**Re: Completeness Review of the LSPGC Collinsville 500/230 Kilovolt (kV) Substation Project (A.24-07-018)
Proponent's Environmental Assessment and Certificate of Public Convenience and Necessity Application**

Attachment A: Submittal Review Form

Description: Data Request #1

KOP 2 – Existing Conditions and Visual Simulation

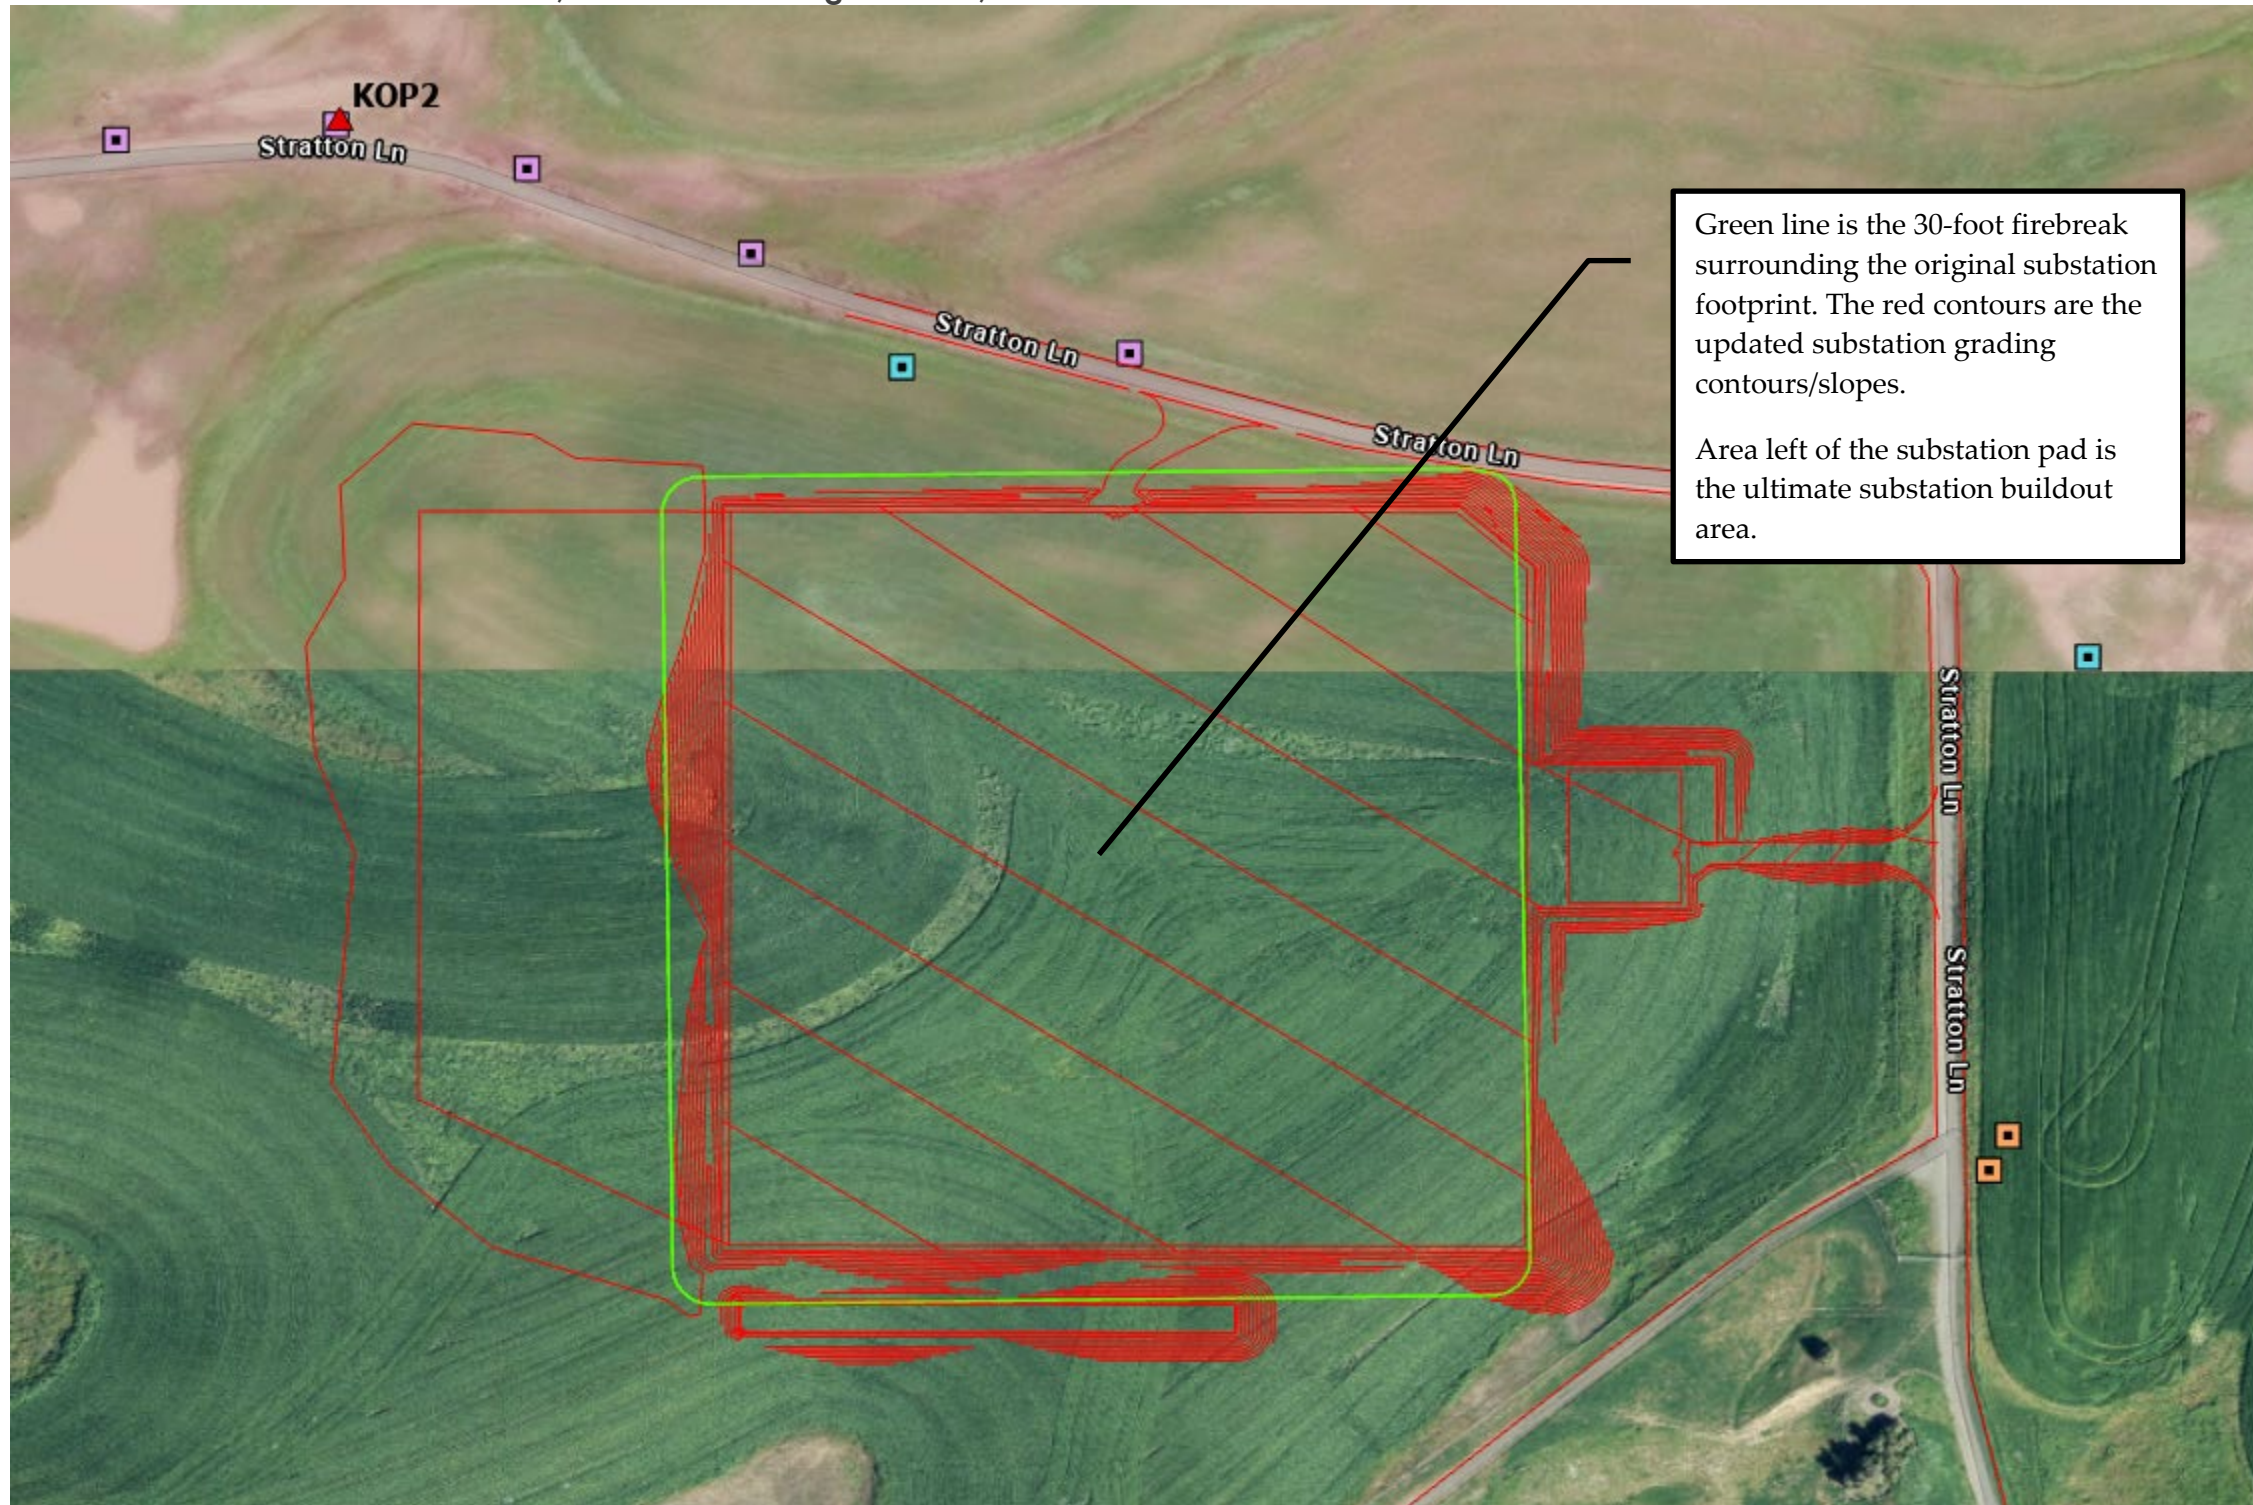
Section/Page Reference	CPUC Comment	Request ID	CPUC Request	LSPGC Response
<p>Visual Resources Technical Report (VRTR) Deficiency Report #1, DEF-10</p>	<p>DR-1: Visual Simulation for Key Observation Point 2 In Response #3 to Deficiency Report #1, LSPGC provided a revised version of the VRTR, as well as updated visual simulations. While the majority of the VRTR and simulation updates are adequate, the visual simulation for Key Observation Point (KOP) 2 does not display (a) the engineered/graded slopes surrounding the substation, or (b) the 30-foot firebreak surrounding the substation, as requested in DEF-10. Section 7.1.2 of the VRTR states: “The proposed north driveway, final graded slopes, and firebreak were modeled as part of the visual simulation process; however, these features are obscured from view at KOP 2 due to the intervening topography in the foreground.” After reviewing the KOP visual simulation, this statement does not appear to be accurate. There is no evidence in the simulation of changes to the existing topography (i.e., grading) that would be required to establish the substation surface. It appears at least some portion of the landscape changes due to grading, engineered slopes surrounding the substation site, and/or the 30-foot firebreak surrounding the substation site would be visible from the KOP 2 viewpoint. The visibility of these features would result in greater visual impacts than currently shown in the KOP 2 simulation. Refer to the DR-2: Reference Information provided at the end of this document for discussion purposes. Note the 10-foot-tall wall in the KOP 2 simulation and the absence of a 30-foot firebreak surrounding the wall. More information is needed to demonstrate that the missing features would not be visible at all, as stated in the VRTR, or alternatively the KOP 2 simulation should be updated to illustrate representative landscape changes and the 30-foot firebreak that would be maintained free of vegetation.</p>	<p>A</p>	<p>Please provide additional information that demonstrates the features were modelled and would not be visible from the KOP 2 viewpoint, as stated in the VRTR. For example, a wire frame simulation could be provided that isolates the features in the 3D model and overlays each in the background image or simulation as a separate color.</p>
